## **STATEMENT OF ENVIRONMENTAL EFFECTS**

### **SECTION 4.55(1A) MODIFIED DEVELOPMENT APPLICATION:**

At: 200 HENRY LAWSON DRIVE GEORGES HALL

**FEBRUARY 2023.**

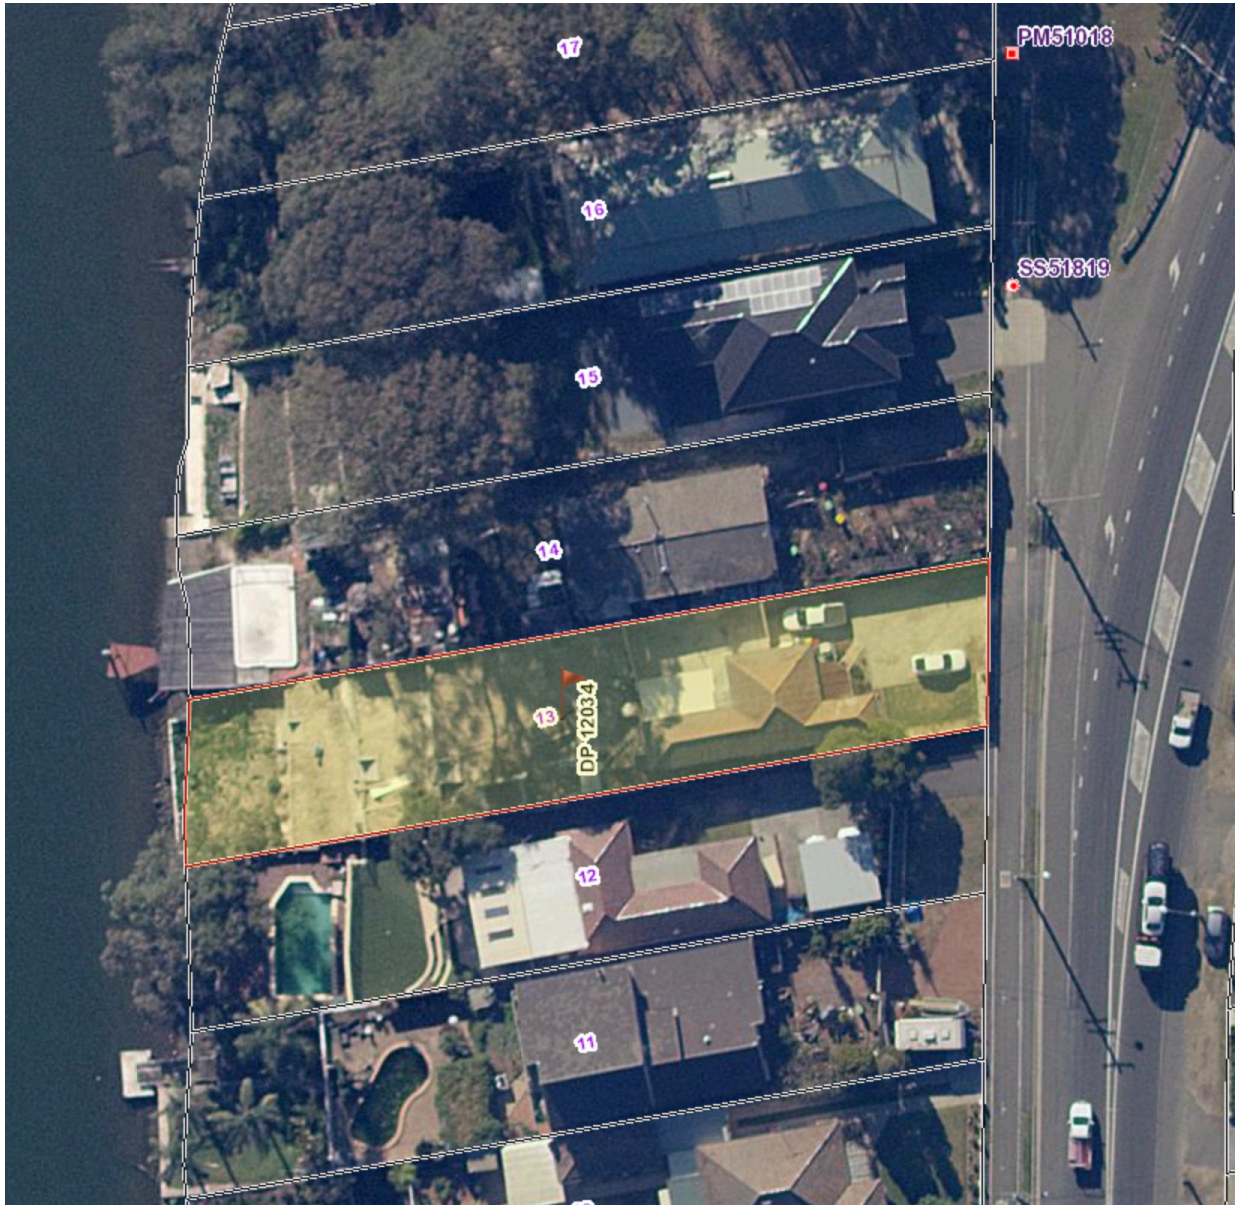
- 
- The modified development application is seeking to delete from the original D.A approval the front brick fence and associated side returns and retain in place the original metal fence as it stands and at the location that it stands.
  - Reason is that a considerable front portion of the site is affected by RMS under (S 27E(6) Main Roads Act.1924 affecting Lot 28 in DP 223358 (Vide K160042) and until such time that RMS takes over the allocated portion of the land, the owners wish to have full use of the land as well be able to service and keep clean and tidy.
  - Therefore, there is no meaning at this stage building a new front fence instead they can be happy with the existing fence as shown on the photograph above.
-
